MIL-C-71150 (AR)
AMENDMENT 1
10 March 1995

CARTRIDGE, 60MM, PRACTICE, SHORT RANGE, M766
LOADING, ASSEMBLING AND PACKING

This Amendment forms a part of MIL-C-71150 (AR), dated 1 November 1993, and is approved for use by the U.S. Army Armament Research, Development and Engineering Center, and is available for use by all Departments and Agencies of the Department of Defense.

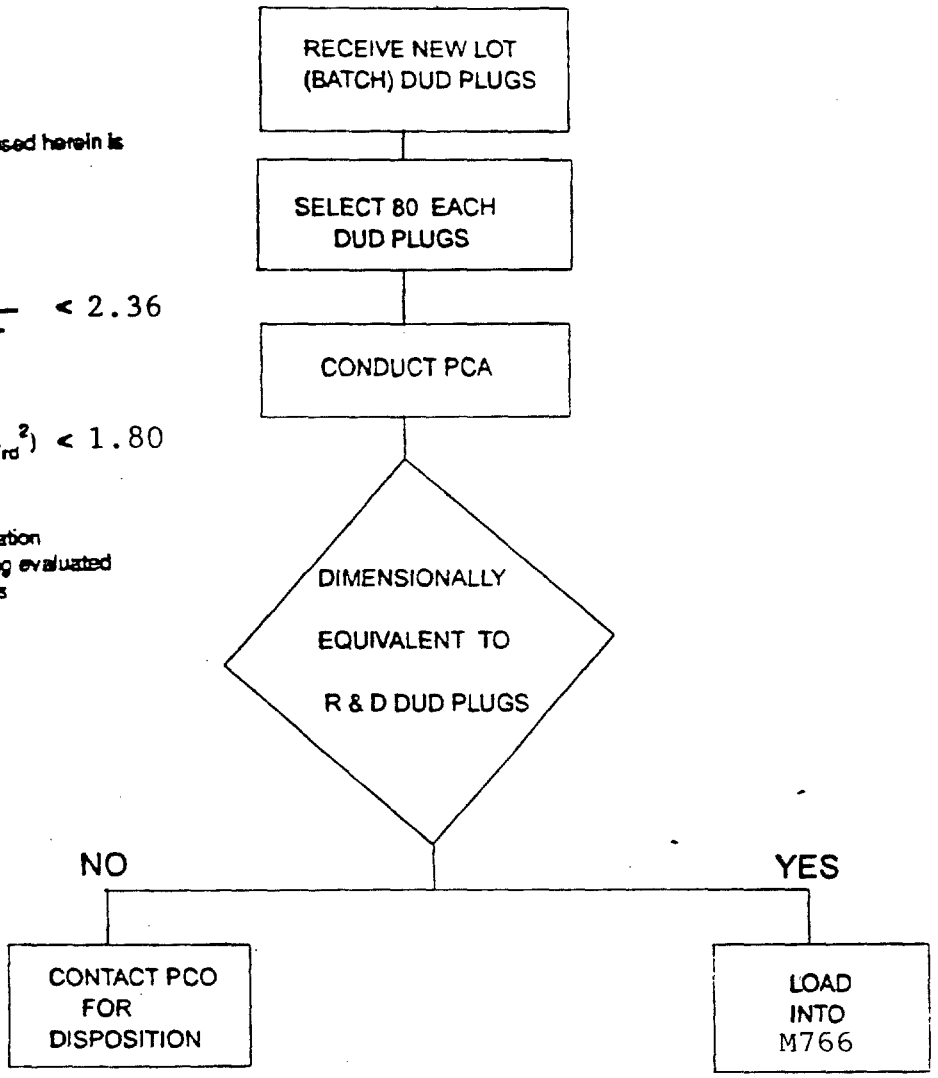
Add new paragraph 6.10 as follows:

"6.10 Dud plug usability criteria. The contractor shall provide dud plug material certification to the government for each inspection lot.

Each inspection lot of dud plugs shall be dimensionally inspected in accordance with the following chart.

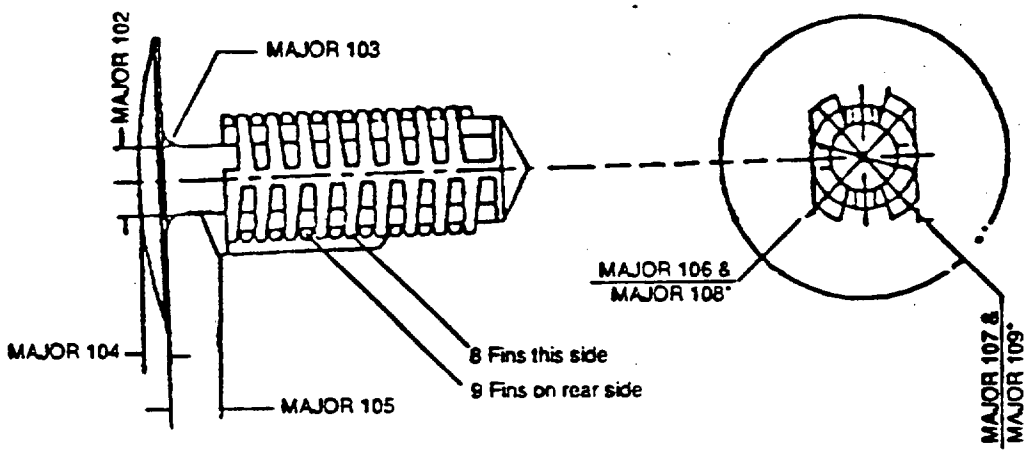
The term "equivalent" as used herein is defined as follows:

Dimensional:

$$\frac{\left|\bar{X}_n - \bar{X}_{rd}\right|}{\sqrt{(s_n^2/80) + (s_{rd}^2/50)}} < 2.36$$

$$(s_n^2)/(s_{rd}^2) < 1.80$$

where: $\bar{X}$ = mean
s = standard deviation
n = dudplugs being evaluated
rd = R&D dudplugs
